**SITE PLAN REVIEW COMMITTEE
MEETING AGENDA**

Item 1. Ballston Station (SP #443) 7:30pm–10:00pm *
(RPC# 14-024-017)
Planning Commission and County Board meetings to be determined.
Michael Cullen/Matt Ladd (CPHD Staff)

ITEM 1
Ballston Station (SP #443)
(RPC# 14-024-017)

SPRC AGENDA: 3rd Meeting – February 2, 2017

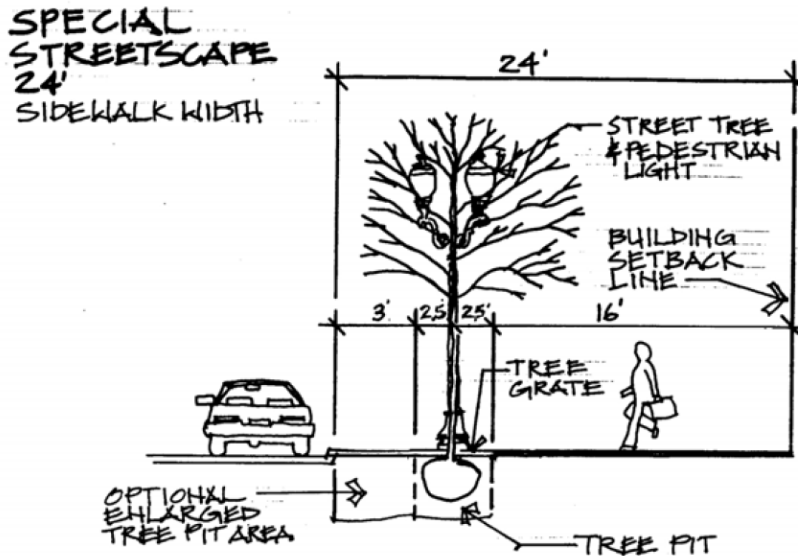
Alley and Site Circulation

The proposed alley off of Fairfax Drive (4.1 Resubmission dated 01/17/2017) poses two issues: 1) width and 2) travel direction. The proposed 30' wide alley width allows for two 11' travel lanes and an 8' parking lane that is to aid in daycare drop-off and pick-up. The existing alley is 11.4' wide and provides one-way-in access to the adjacent retail parking lot. The proposed alley is to provide two-way site circulation which is not supported by County staff. Eliminating the exit travel lane would result in a 19' one-way-in alley that still accommodates the daycare use at the site while minimizing the curbcut on Fairfax Drive for pedestrians and bicycle users. *Note: A subsequent applicant document (SPRC #3 Presentation received by staff on 01/26/2017) shows a new design for the alley: a 12' wide driveway curbcut from Fairfax Drive and a 12' wide northbound only travel lane with an 8' wide parking lane adjacent to the building. Staff is in support of the redesign of the center alley.*

Ideally, with a future re-development of the western side of the block, the Fairfax Drive curb cut could be eliminated and all of the site's circulation would occur via a two-way back alley connecting N. Stafford Street and N. Stuart Street, parallel to Fairfax Drive. The current parking garage entrance does not easily support the elimination of the Fairfax Drive curb cut and the proposed 16' wide one-way (eastbound) alley precludes future conversion to a two-directional alley. Staff supports the rear alley to remain one-way until the rest of the block is redeveloped, but would like for a 20' width so that it could be converted to a two-way alley in the future. *A subsequent applicant document (SPRC #3 Presentation received by staff on 01/26/2017) shows a new design for the rear site alley at 18' wide, which still precludes future conversion to a two-way alley. Staff would like to see a minimum 20' wide rear alley.*
